## HISTORIC AND DESIGN REVIEW COMMISSION

**HDRC CASE NO:** 2018-615  
**COMMON NAME:** Rivercenter Mall  
**ADDRESS:** 106 ALAMO PLAZA  
**LEGAL DESCRIPTION:** NCB 151 LOT 3, A1,A2,A3,A4,A5,A6,7,8,60,61, 62,63,65,A66 & 64 EXC SW 32 FT (2.533 AC) & NCB 1010 BLK 2 LOT 26 (.99 AC), 28 (1.44 AC), 31 (.71 AC) & PT OF LOT 30 (5.11 AC)  
**ZONING:** D, HS, RIO-3  
**CITY COUNCIL DIST.:** 1  
**DISTRICT:** Alamo Plaza Historic District  
**LANDMARK:** Joske's Dept Store  
**OWNER:** New Rivercenter Mall II, LP  
**TYPE OF WORK:** Construction of a patio seating and performance area  
**APPLICATION RECEIVED:** November 30, 2018  
**60-DAY REVIEW:** January 29, 2019  
**REQUEST:**

The applicant is requesting conceptual approval to construct a patio at the river/lagoon area for outdoor seating as well as performances. The patio will feature permanent seating; however, will have the ability to be removed if needed for various circumstances.

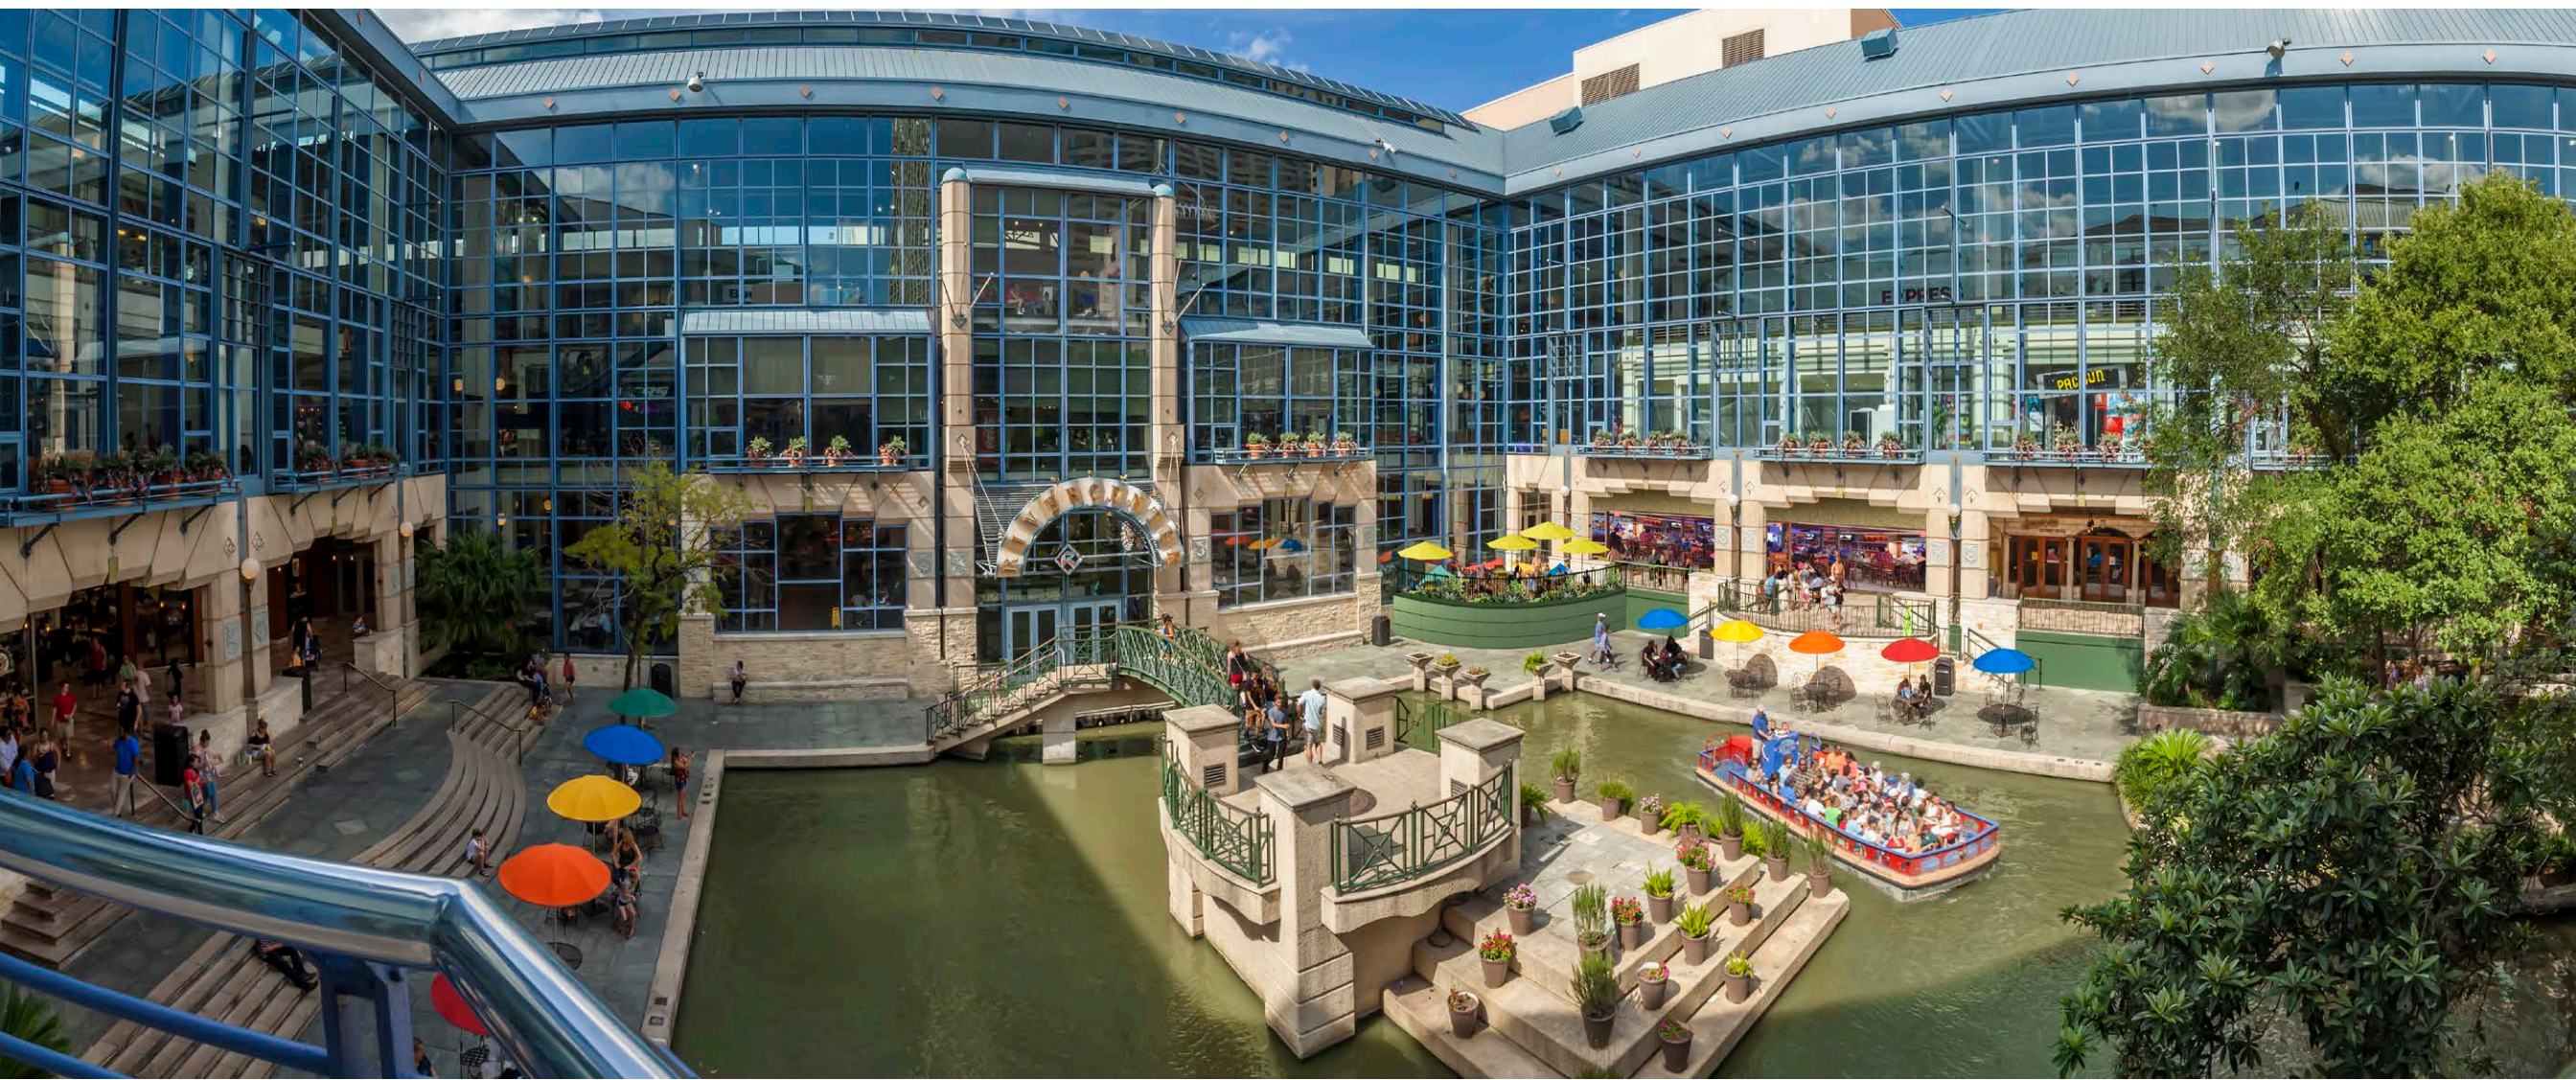
- a. The applicant is requesting conceptual approval to construct a patio at the river/lagoon area for outdoor seating as well as performances. The patio will feature permanent seating; however, will have the ability to be removed if needed for various circumstances.
- b. DESIGN – The applicant has noted that the proposed patio will be designed in a manner that is to be permanent; however, will feature the ability to be removed under certain circumstances. Additionally, the applicant has noted that the patio will feature an overall design that is consistent with the design and materials that are found in the mall at the lagoon.
- c. MATERIALS – The applicant has noted that the materials of the patio will be consistent with those that are found throughout the lagoon level of the mall. Staff finds this to be appropriate.

- i. That the design of the proposed patio feature a profile, details and materials that are consistent with those existing at the lagoon level.
